**From:** Jon McDonald  
**Sent:** Thursday, November 9, 2023 10:08 AM  
**To:** Ante, Magdalene A; Katz - DNR, Aaron  
**Cc:** Woodruff, Chad W  
**Subject:** RE: [EXTERNAL] Re: Notice of MIRU on RGU 331-24-198

The P&A on this RGU 331-24-198 started.

**Recommendation/Request for approval:**

STEPS updated: **7.5, 10,11**

**RGU 931-24-198 P&A Dryhole marker details:**

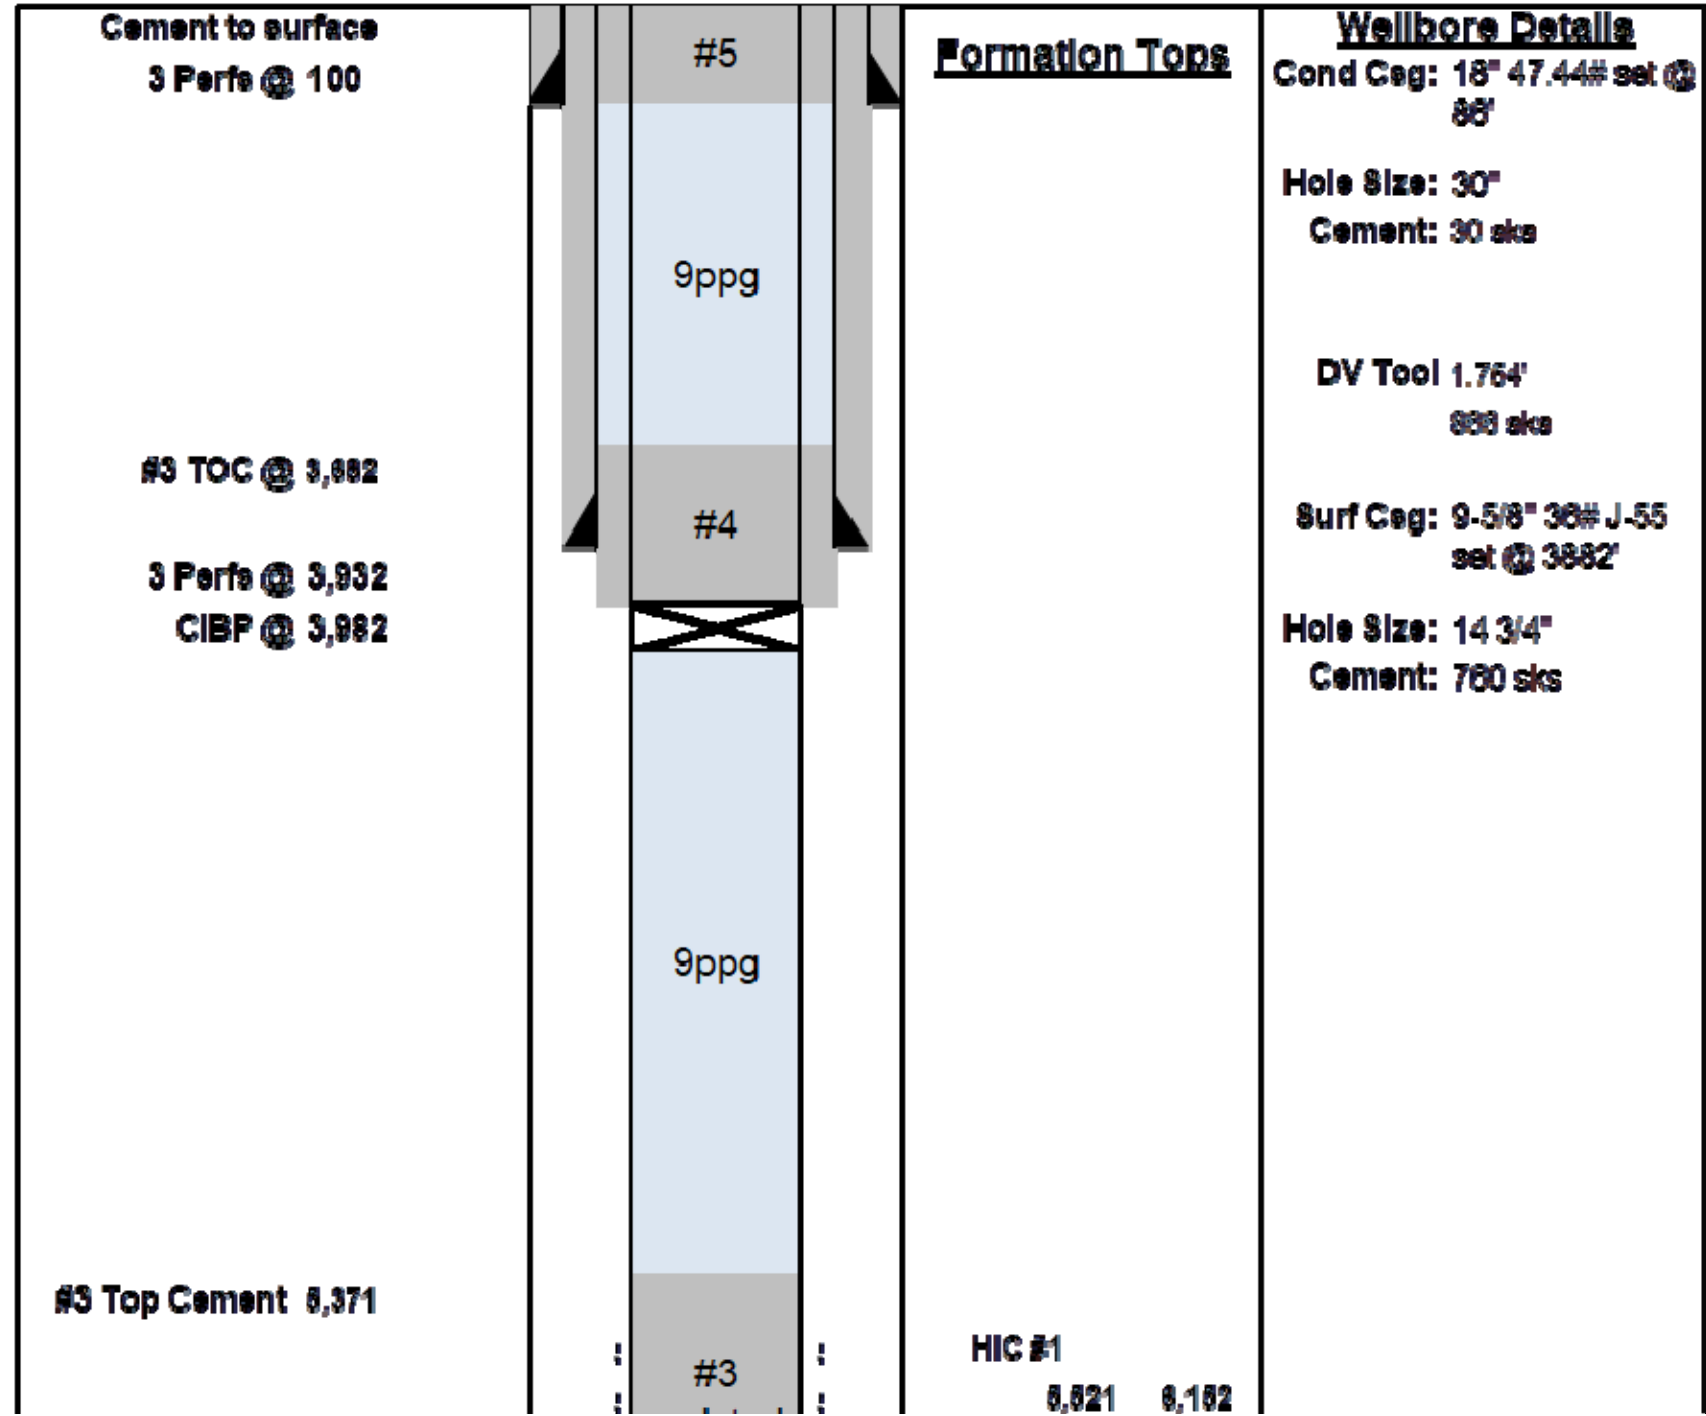
- Continue with step #8 (Ohio creek balance plug) with no changes.
- Updated Step #10 & 11 with increased sks of cement + starting balance plug 50' below bottom of HIC #2 (Detailed below)
- We will likely be ready to pump this job around Noon tomorrow so the 'go ahead' ASAP would be appreciated!

We found another HIC below the known HIC. This was because it was below the TSBP set at 6474' so during the csg repair earlier this year we did not find the leak. Below is the recommended steps to isolate the additional csg damage that was found.

This leak should be minimal leakoff with the injection rate we established, is below TOC, so increasing our cement slurry to pump additional cement across this HIC #2 & HIC #1 should not complicate this balance plug.

<b>#3 HIC cement balance plug (5371-6548')</b>			
1.177.0	(10) 4-1/2" csg + 30% excess		
23.8	bbls	117.0	#sks (round up)
UPDATED 11/6/2023**

7.5 Isolated HIC #2 6466-6498'. Pressure tested 6498' to C BP for 1000# 30min. (UPDATED 11/6/2023)

10 POOH with end of tbg to appx 6548' (50' below bottom of HIC#2). (UPDATED 11/6/2023)

11 Pump and displace appx 117sk (23.8bbbls) of cement for balance plug across HIC#1 at 5521-6152' and HIC#2 6466-6498'. Balance plug is 1177' + 30% excess (UP DATED 11/6/2023)

Please proceed with your proposed update. Please report TOC and pressure test result post-HIC plugs before proceeding to the next step.

Good Morning Jon, Thank you for the update. The proposed changes are okay with me and please proceed as outlined.
